L83X-A.01.14

To: Official After Sales Network
Subject: Installation Of Rubber Boot Onto Alternator
Date: 14th/02/14
Pages 4

Installation of rubber boot onto alternator.

All Lamborghini Model Aventdor MY 12, 13 and 14 Coupe And Roadster from VIN CLA00091 to VIN ELA02542.

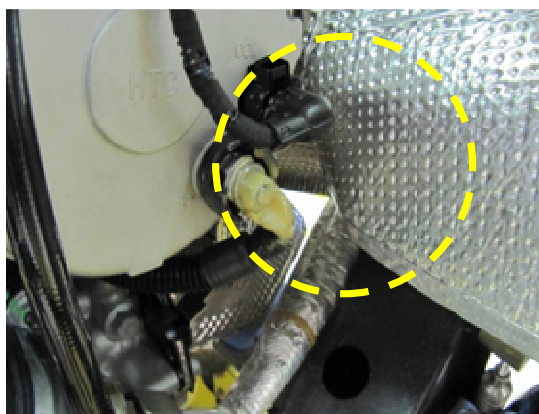
7. Bent the firewall corner in order to distance it from the positive cable.

8. Check the distance between firewall and positive cable is 25 mm.

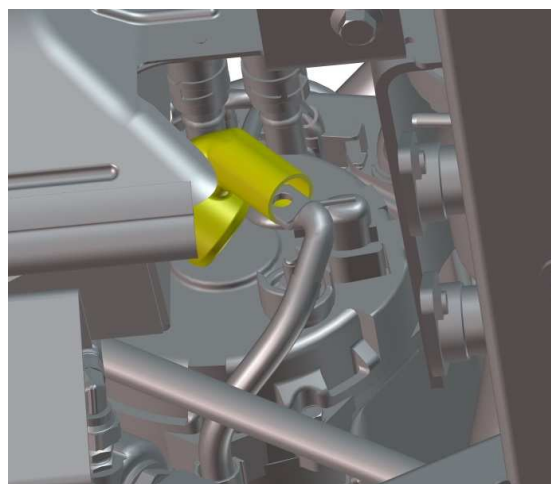
9. Fit rubber boot.

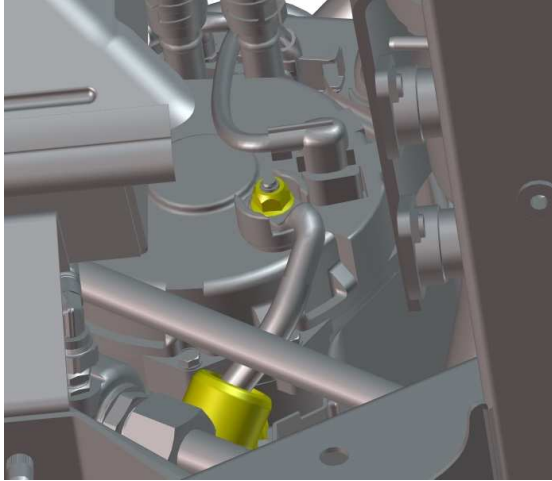
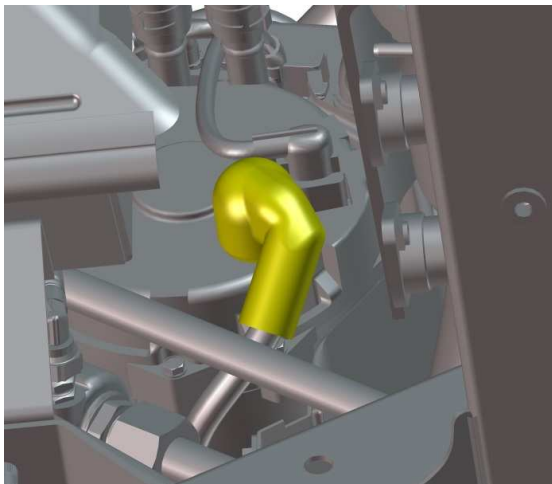
10. Place correctly the cable and fasten the nut
Apply on nut protective wax for electrical contact suitable for automotive application.

Torque: **20 Nm**

11. Let rubber cup fit well with nut as shown
